From: drainage <drainage@midsussex.gov.uk>
Sent: 11 March 2026 16:37:54 UTC+00:00
To: "Stefan Galyas" <Stefan.Galyas@midsussex.gov.uk>
Cc: "drainage" <drainage@midsussex.gov.uk>
Subject: 2026.03.11 Re: DM/26/0387 - 1 Withy Bush Burgess Hill West Sussex RH15 8TT

We understand the proposed application is to remove existing conservatory and erect a two storey extension with alterations to main staircase to access extension.

The Flood Risk Assessment provided by FloodPlan Limited dated 26 February 2026 has been reviewed and we would comment as follows:

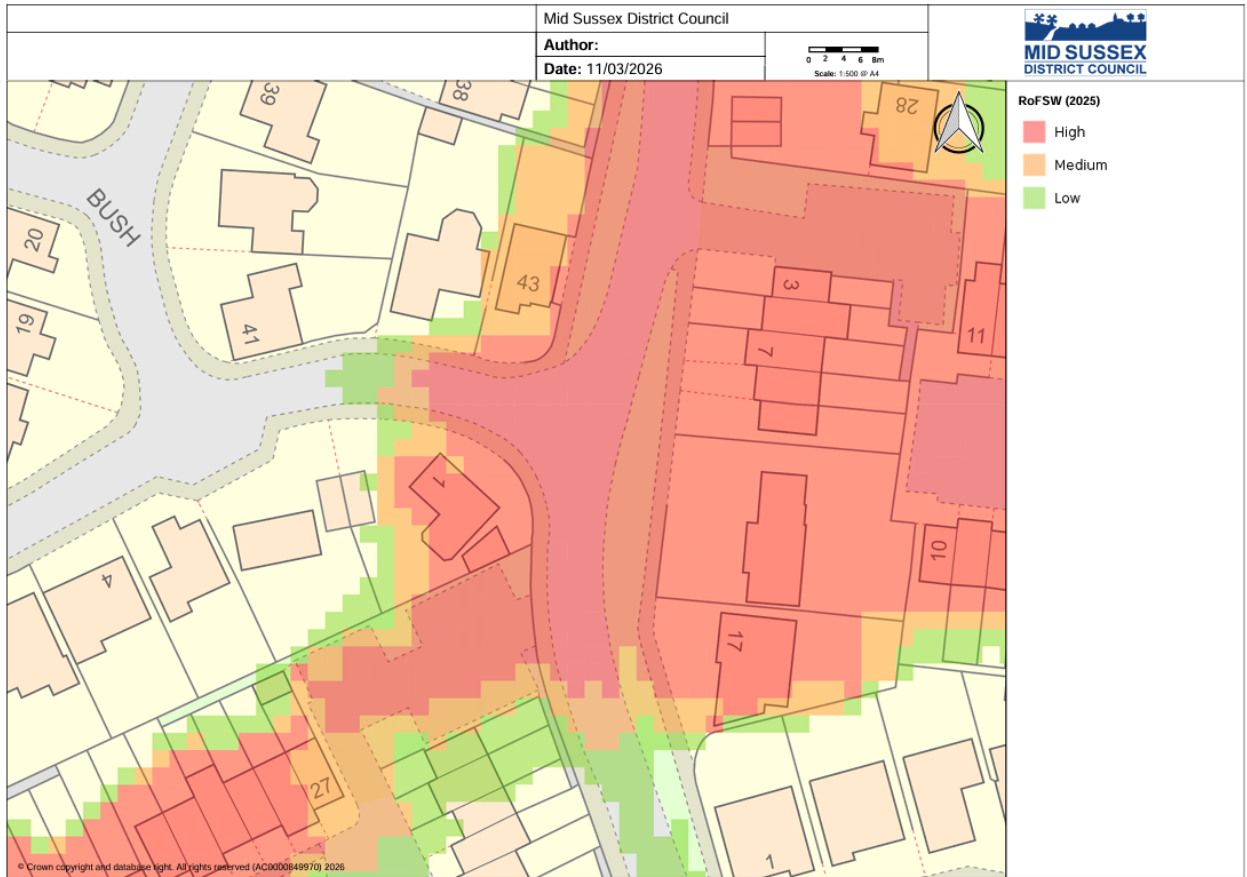
However, the Environment Agency's Risk of Flooding from Surface Water (RoFSW) mapping indicates that the site is shown to be at very low to high surface water flood risk (comparable to Flood Zones 1 to 3b). The area of high surface water flood risk is associated with a flow path running from the rear to the front of the property.

The applicant has failed to demonstrate that the increase in built footprint is located outside of the 1 in 30-year surface water flood extent. In the absence of such evidence, and based on the latest flood risk mapping, part of the extension is considered to fall within the equivalent of Flood Zone 3b (functional floodplain).
